**RE: Phase III Bond Release, Plateau Mining Corporation, Star Point Mine, C/007/0006,
Task #4320**

INSPECTION NARRATIVE

Figure 3: Small area with coal refuse at the surface

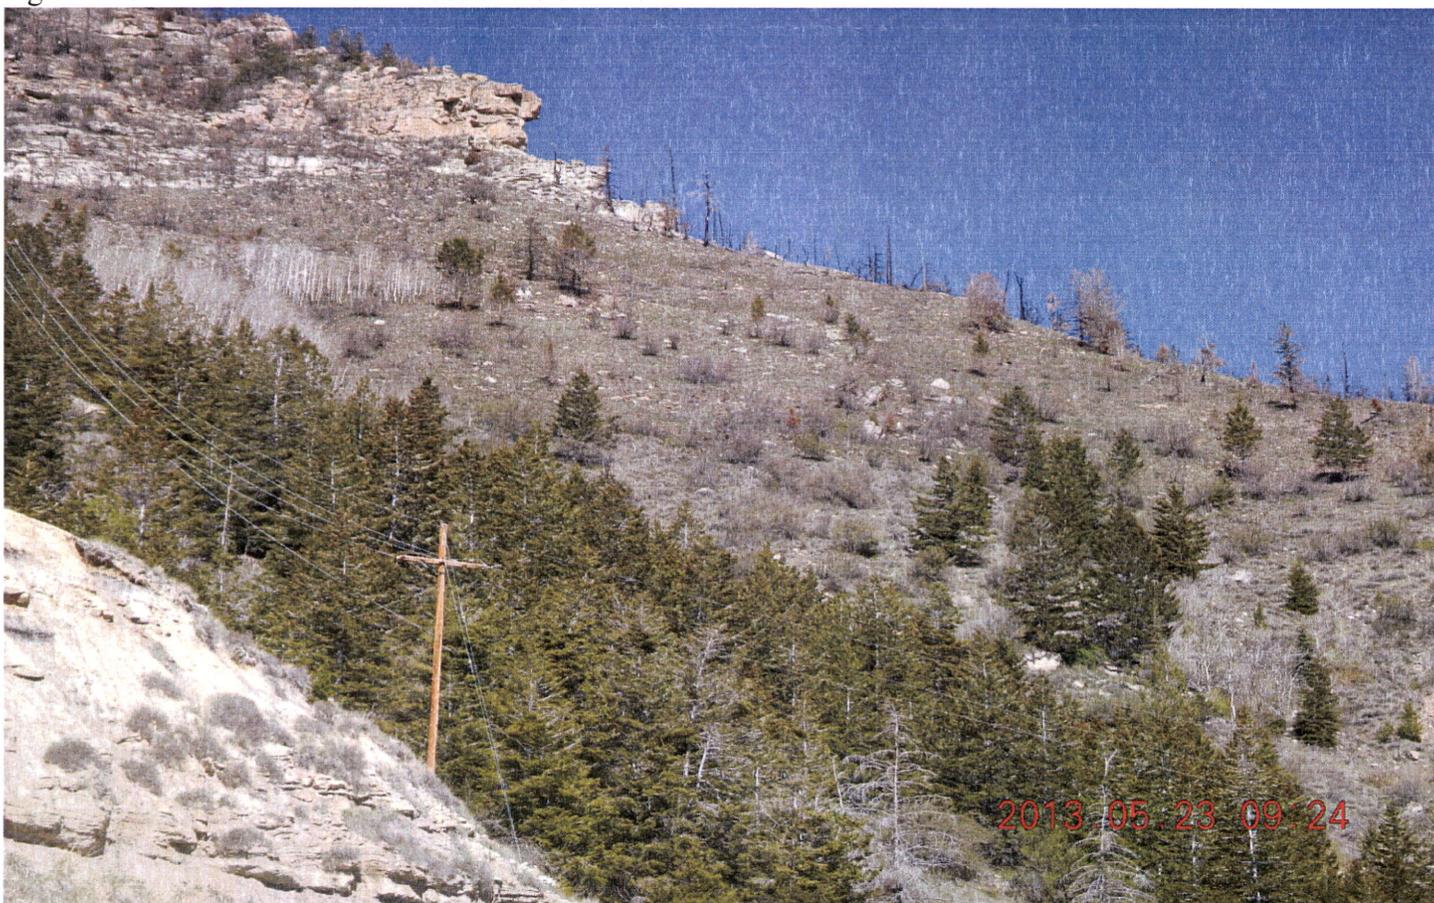
It was noted that there was an area on the No. 2 Mine where it appeared that coal refuse had either been mixed with the topsoil substitute material or that the overlying material had eroded away and exposed some coal refuse. This area appeared to consist of less than a quarter acre and had minimal vegetative cover on it. This should have been addressed either in previous bond release phases or otherwise in DOGM's inspection and enforcement program. See Figure 3 for details.
